RE: Lewis Dull Demolition Landfill, Permit No. 39-A, Lake Road,
 Dutchville Township, Granville County, North Carolina

PLAN REVIEW COMMENTS

Project Name: Dull's Demolition Landfill Date Received: 6-11-91
Location: Granville County Date Processing Initiated: 6-11-91
Reviewed By: JLH

RE: Lewis Dull Demolition Landfill Application, Completeness Review

Horiz = 1" = 50'
 Vert = 1" = 5'

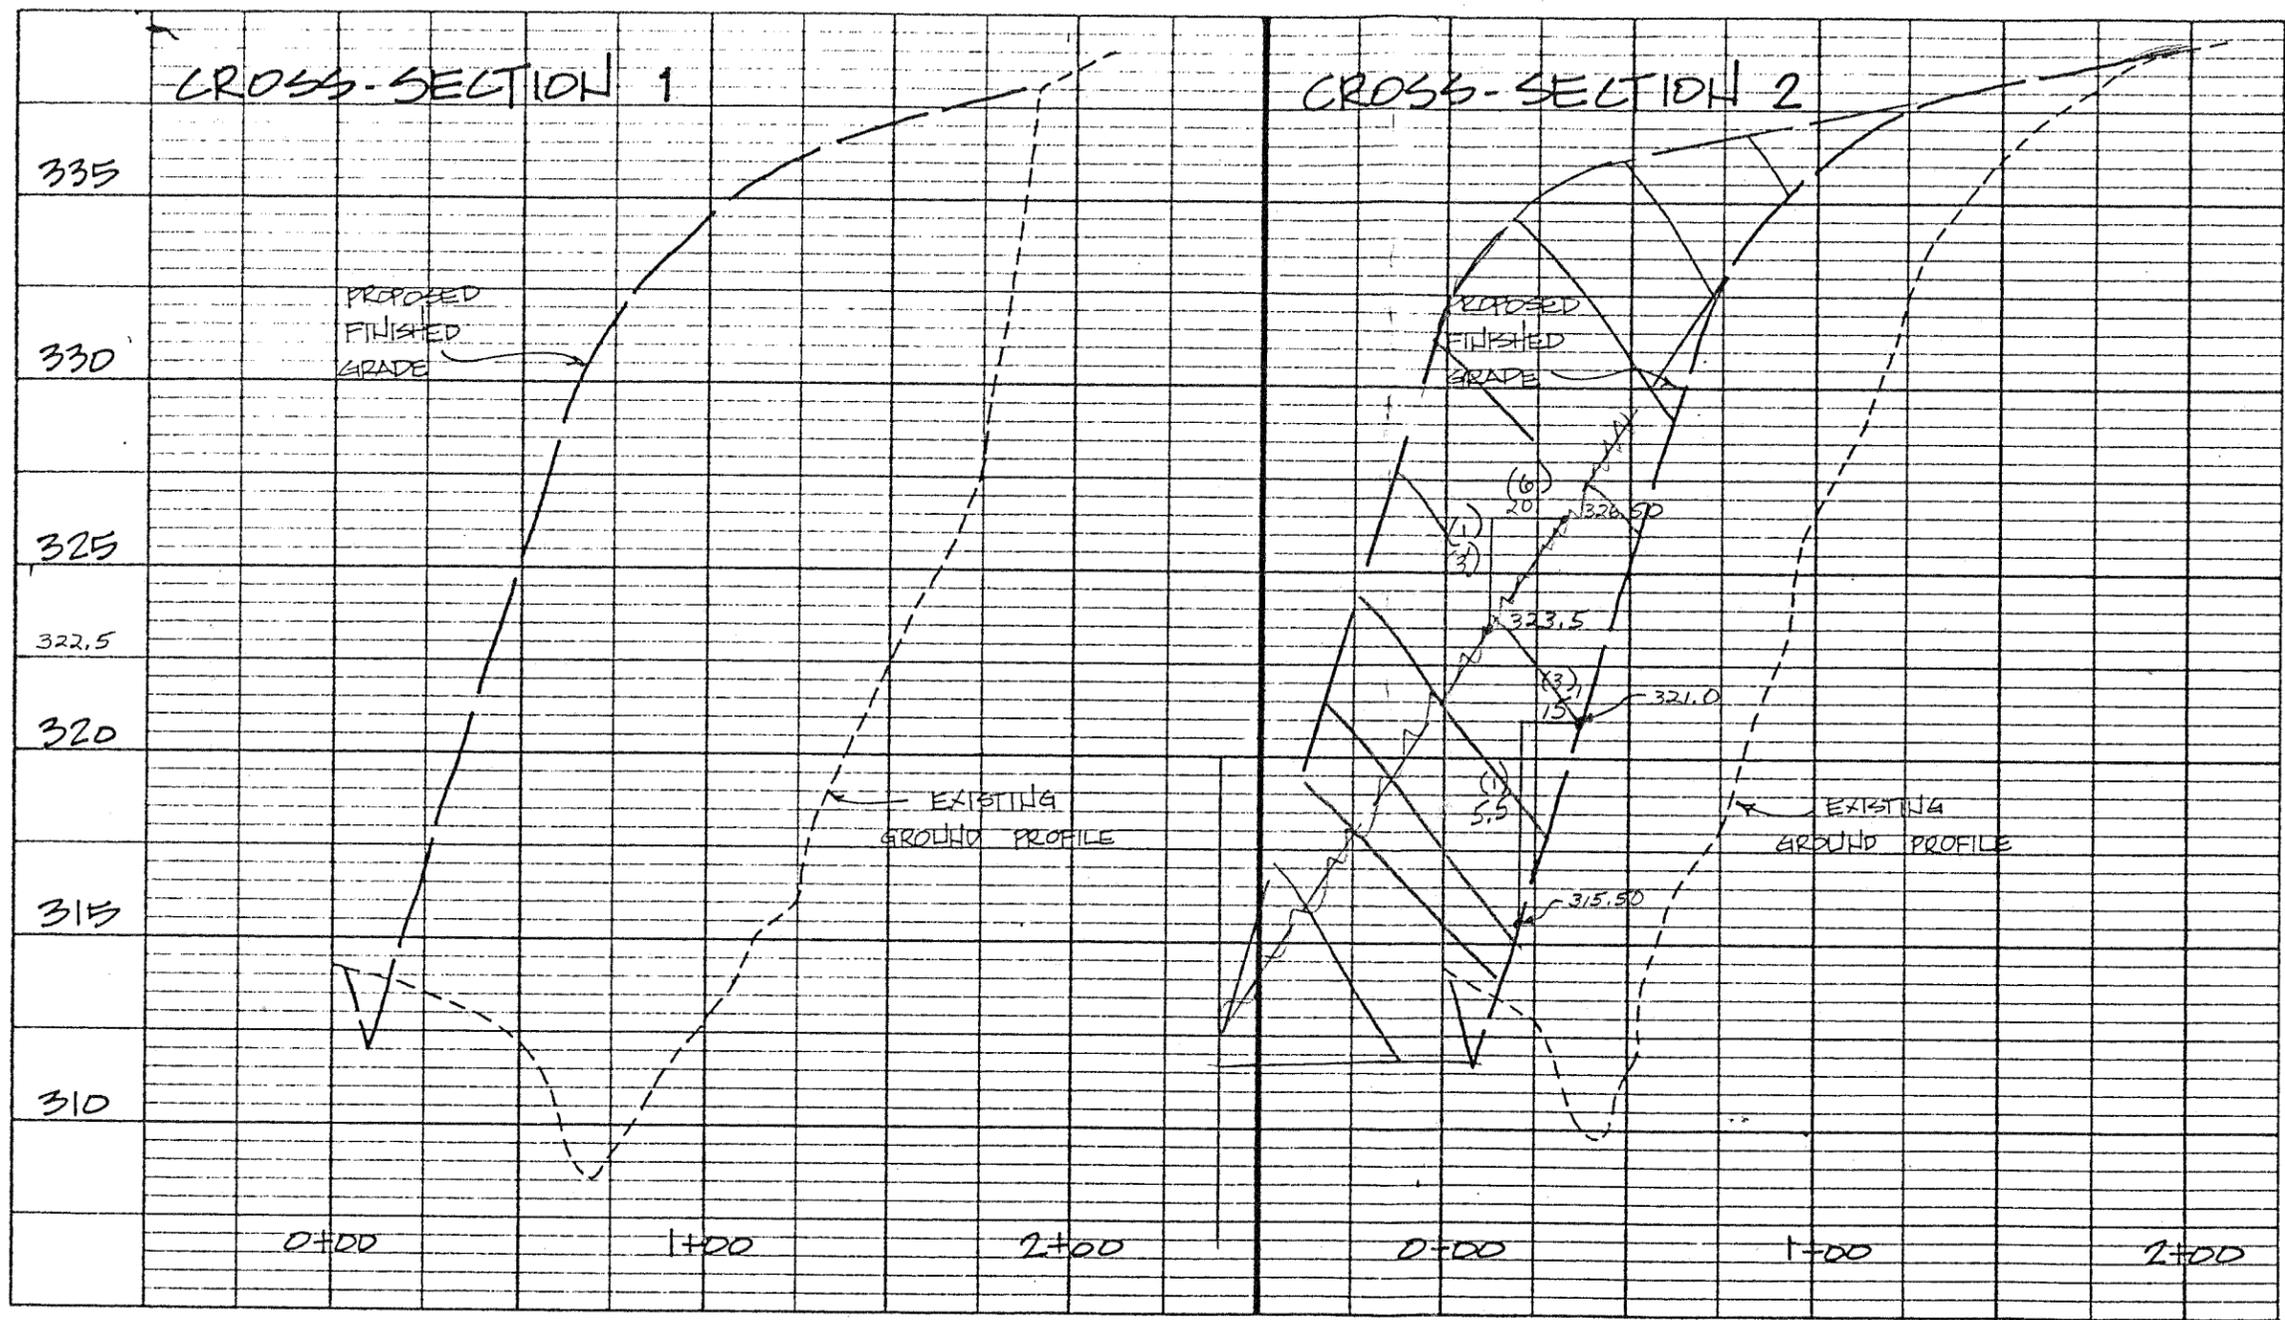
1. Final slopes must be no steeper than 3:1.
2. Landfilling operations must be carried out only as approved by the Division of Solid Waste Management and may not proceed until their approval is obtained.

1" = 200'

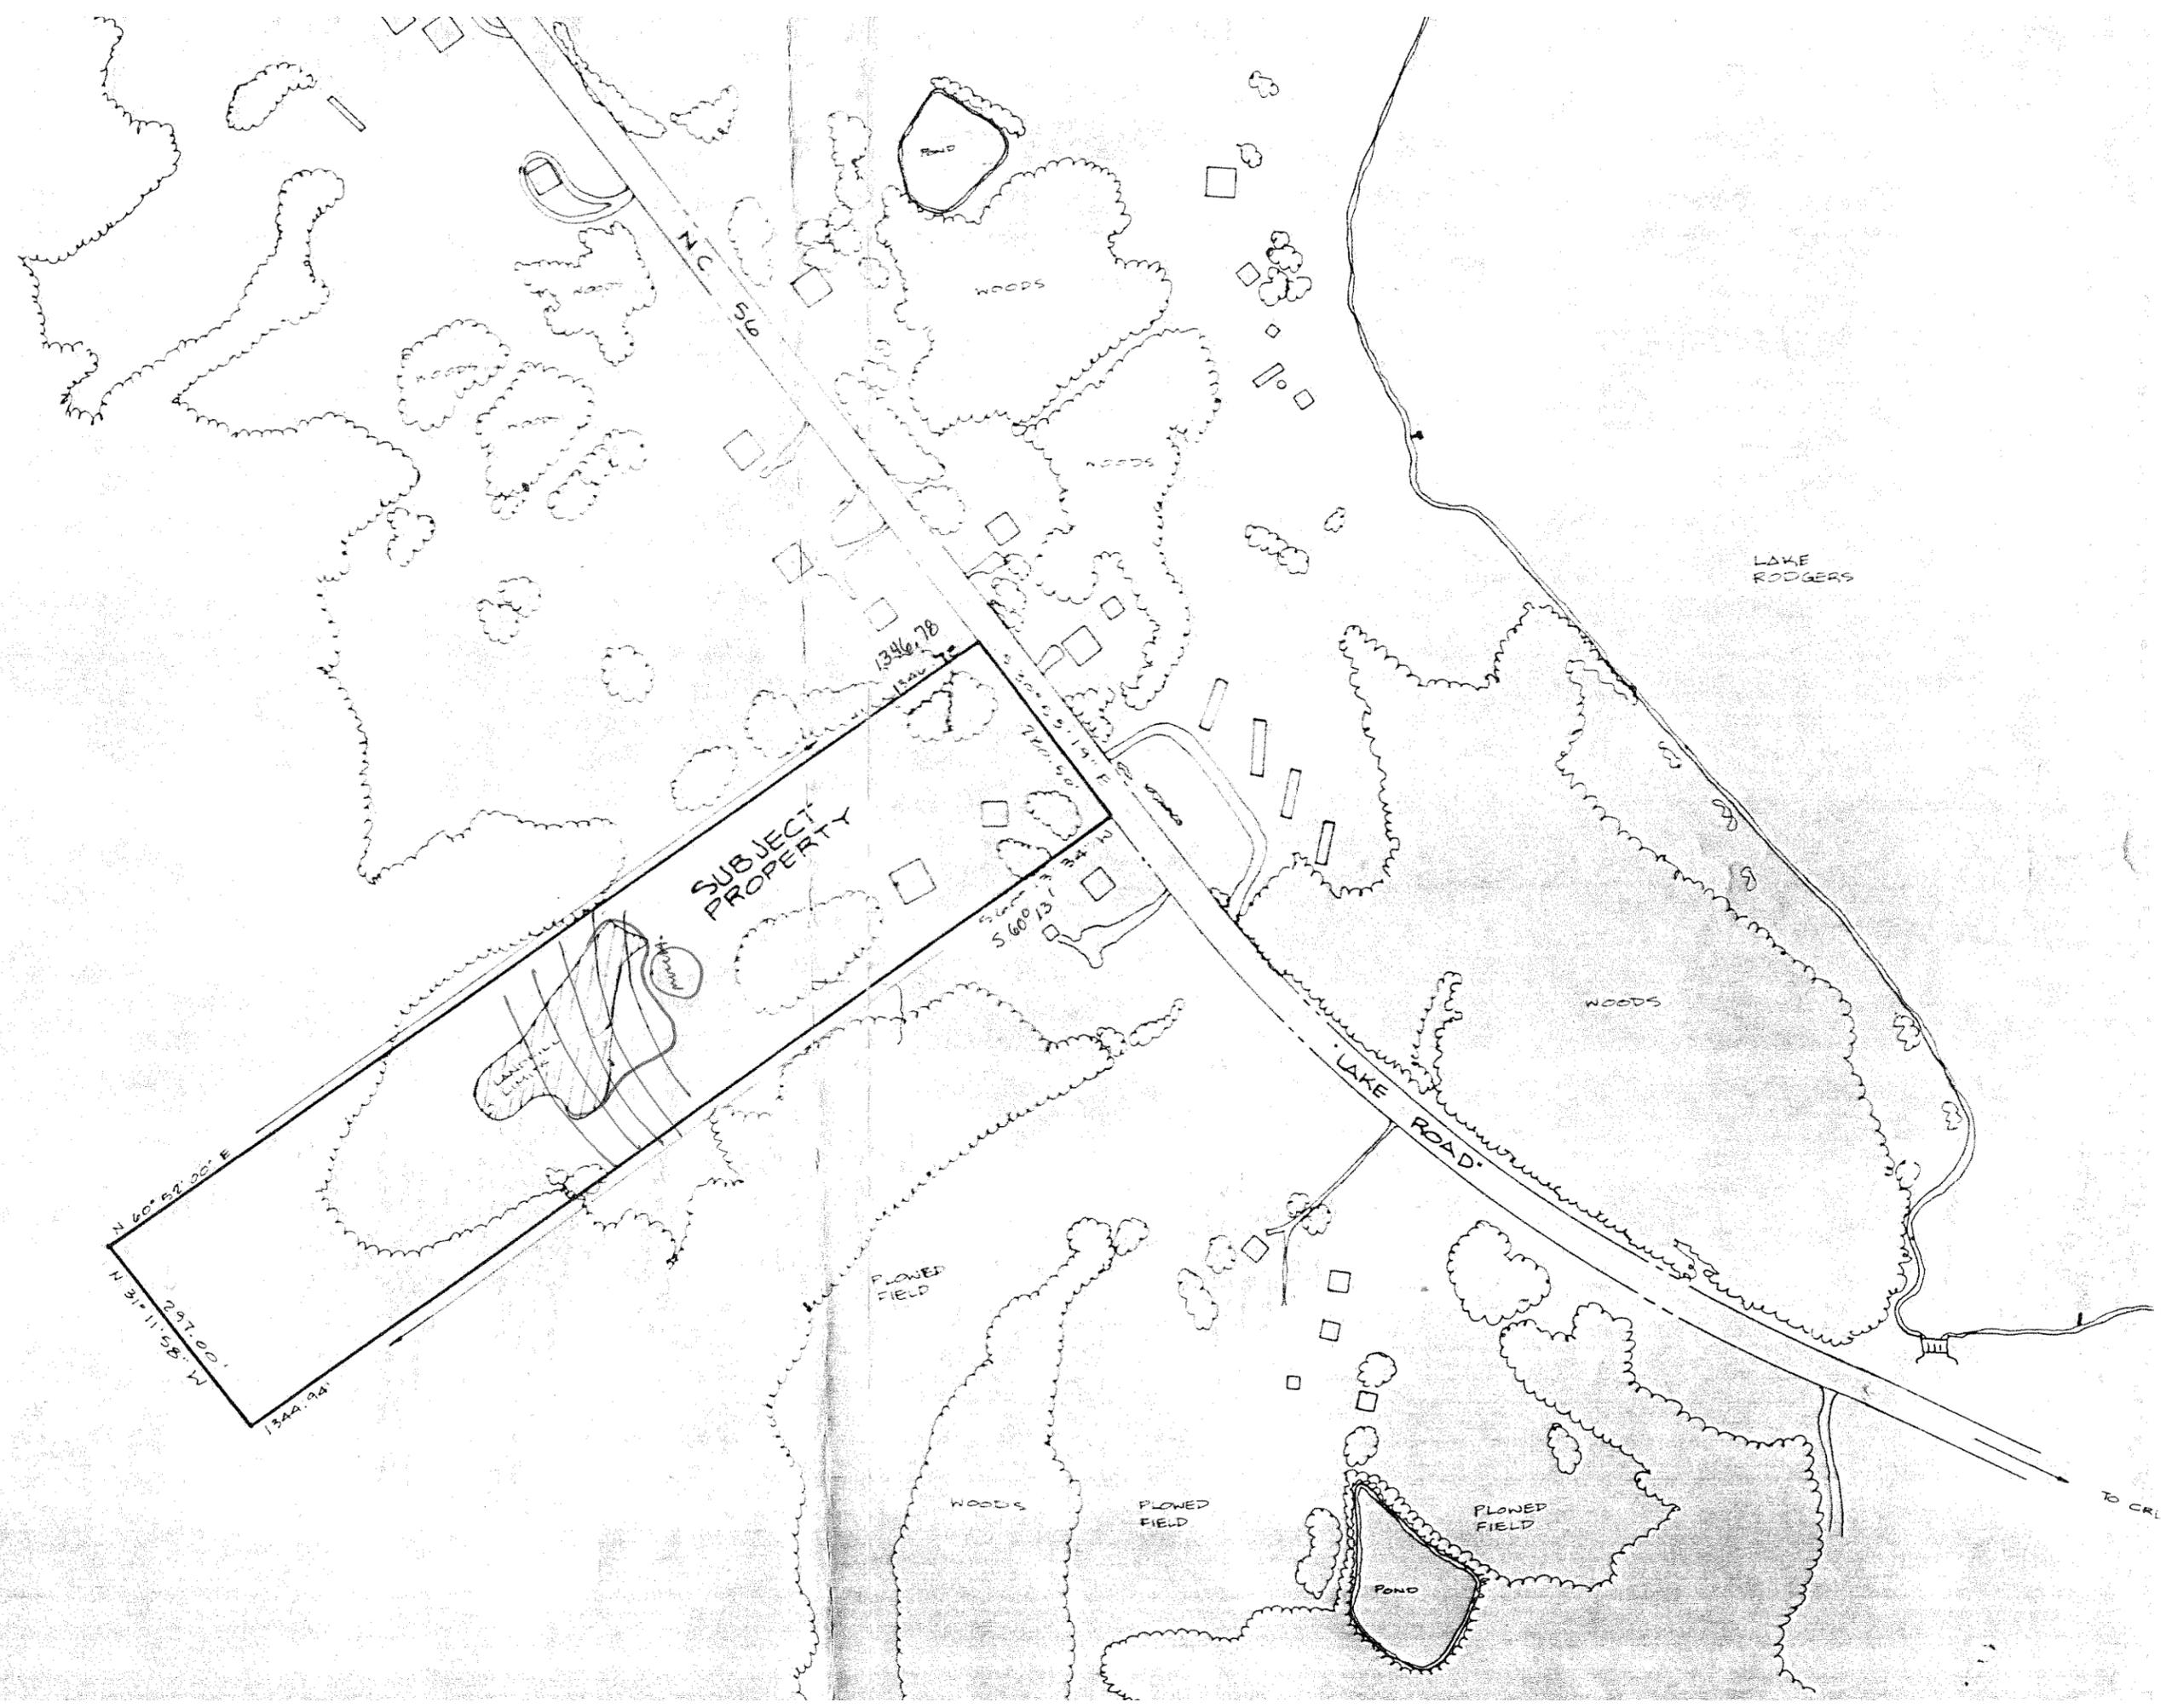
SITE NEEDS TO
BE CLOSED.

PERMITTED UNDER
OLD DEMO RULES.
